Thank you for your interest in the Xilinx XC3S700A FPGA device engineering samples. Although Xilinx has made every effort to ensure the highest possible quality, these devices are subject to the limitations described in this errata notification.

Table 1: XC3S700A Devices Affected by These Errata

Figure 2: DCM DFS Lock Failure Workaround

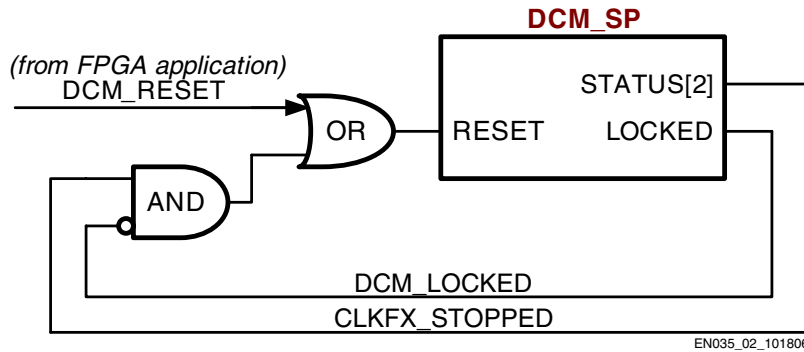
A small number of DCM DFS locking failures have been observed during characterization.

A software workaround exists, as shown in [Figure 2](#). This circuit is automatically inserted by the ISE development software starting with version 9.1i. Using FPGA logic, the circuit monitors both the LOCKED output from the DCM\_SP function and the STATUS[2] bit, which indicates that the DFS output CLKFX has stopped. If LOCKED = 0 and STATUS[2] = 1, then the circuit asserts the DCM RESET input. If the FPGA application also resets the DCM, then OR the reset signal from the FPGA application with the monitored output signals.
